Docket Item # 11 & 12
BAR CASE # 2010-0049/0050

BAR Meeting
April 21, 2010

ISSUE: Permit to Demolish/Encapsulate & Addition

LOCATION: 812 South Lee Street

Figure 2: Existing elevations.

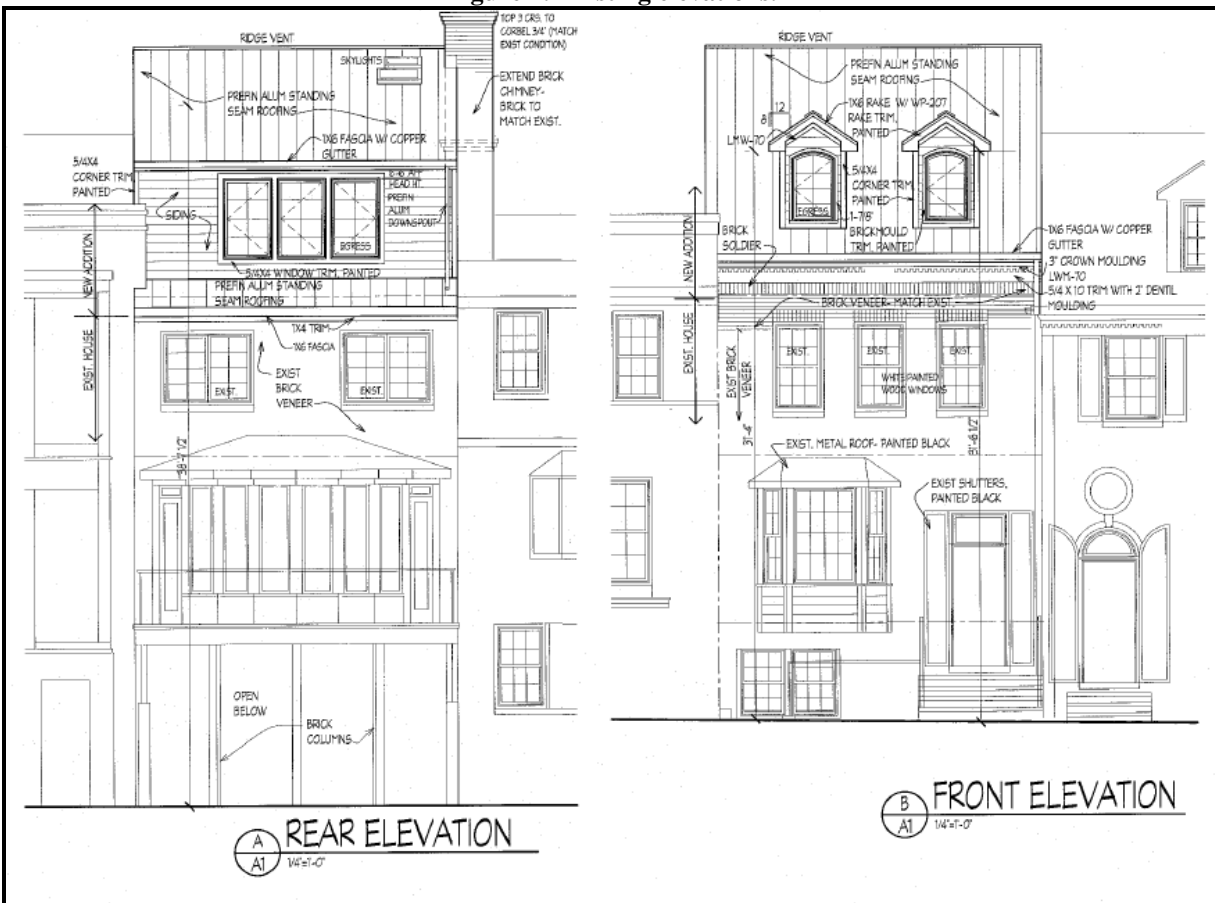
The area of demolition consists of the entire roof structure, including the existing gable roof with single dormer and the flat roof at the rear of the house, an area of approximately 871 square feet.

Figure 3: Proposed elevations.

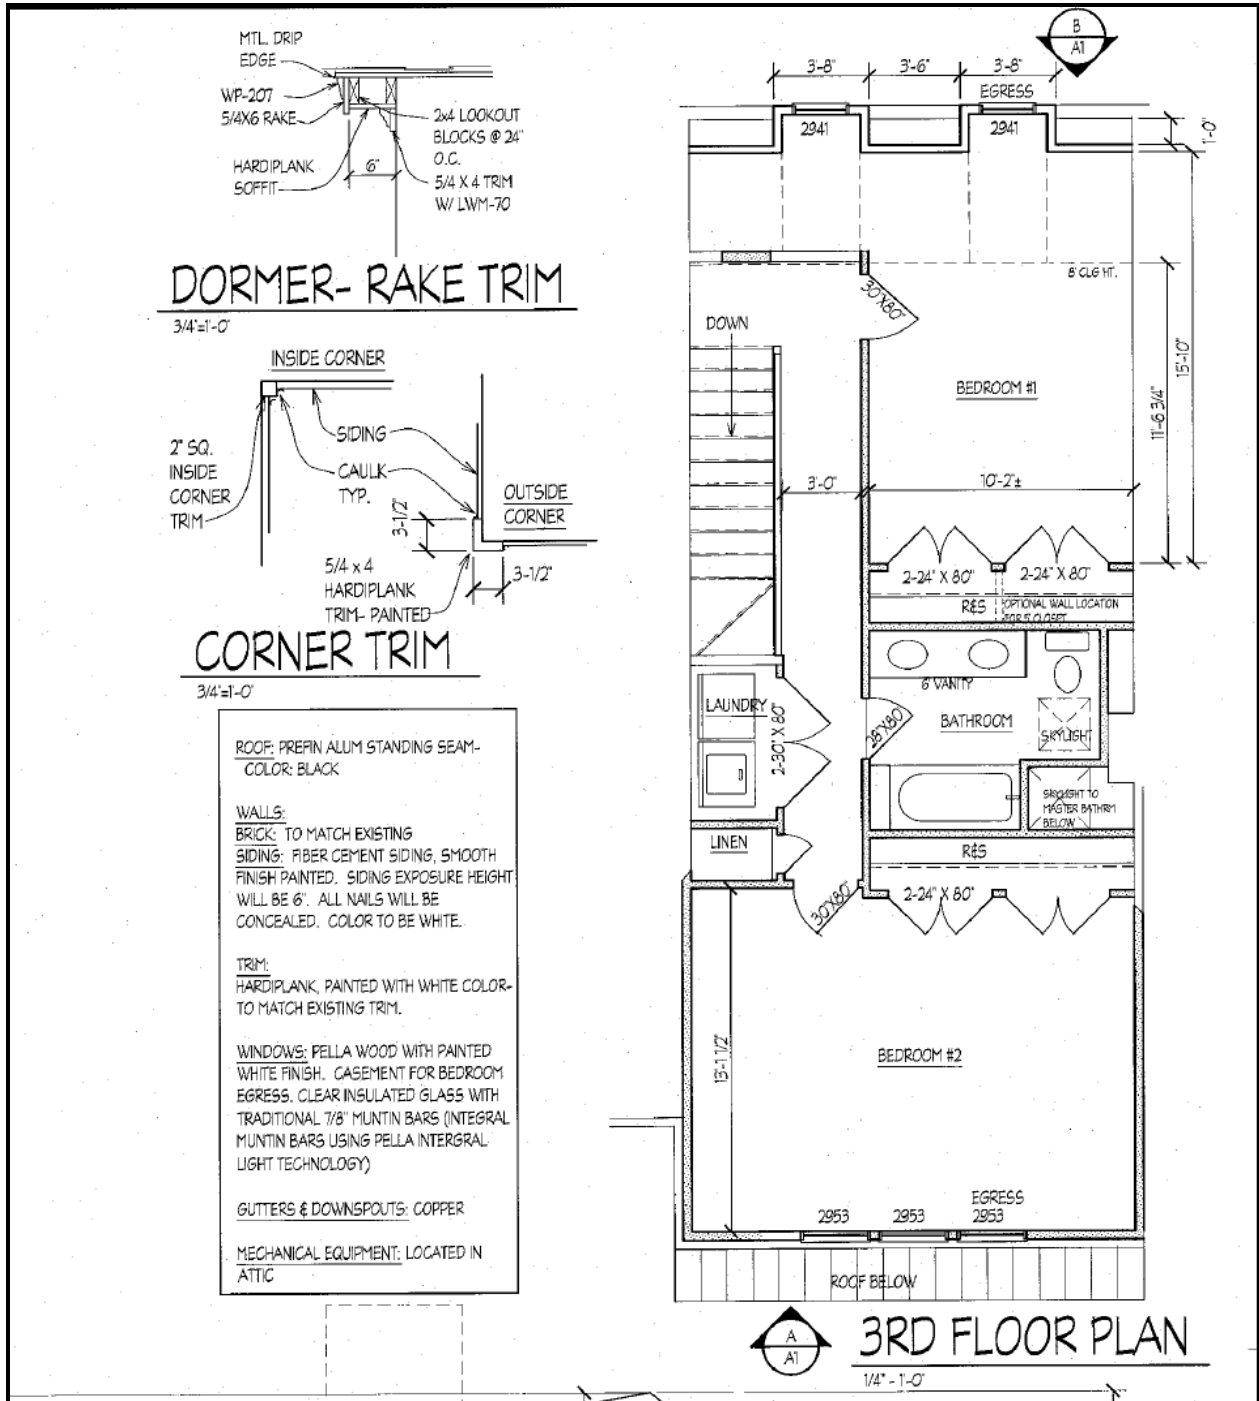
The applicant proposes to install a new roof with a ridge height approximately 4 feet 8 inches higher than the existing front gable, thereby changing the front roof pitch from an 8/12 slope to a steeper 11/12 slope. The new roof will appear to have a gable roof form from the front, but the rear will have a more gradual slope, with a 2.5/12 pitch. The front façade will be increased in height by approximately 2 feet 9 inches, which will be accomplished using a matching brick veneer. A brick soldier course will be added above both of the exiting windows on the second floor, as well as just below the new HardieTrim cornice. The gutters and downspouts will be constructed of copper. As a result of the proposed height increase, the chimney must also be raised. The addition will have HardiePlank siding and a prefinished aluminum standing seam metal roof in black. Two skylights will be installed on the rear slope of the roof. The HardiTrim and HardiPlank will be painted white.

On the front elevation of the addition there will be two pedimented dormers, each with a multi-light casement window. Three multi-light casements will also be centered on the rear elevation. The simulated-divided-light wood windows will be manufactured by Pella with double-insulated glass and 7/8 inch muntins.

While Staff has no objection to a modest increased height of the front façade and conversion of the attic into a habitable third floor, the height and pitch of the new roof, along with the two

dormers, accentuates its mass relative to its neighbors. Staff proposes that the applicant lower the proposed roof to match the slope of the existing (and adjacent) gable roof. Installing only one dormer on the front slope of the roof, instead of the two proposed dormers, will also help to reduce the visual mass of the addition against the sky and is consistent with all but one of the gable roof townhouses in this row. Staff estimates that the revised roof would result in a height increase of between 2 and 3 feet, not the 4 feet 8 inches proposed by the applicant. The rear roof slope could then be nearly flat to maximize the square footage on this part of the house.

In summary, Staff does not object to the demolition or construction of a third floor addition at 812 South Lee Street. However, Staff believes that the current proposal adds unnecessary height to the townhouse, making it incompatible with its immediate neighbors. Staff recommends that the application be deferred so that the applicant can restudy the height of the addition.
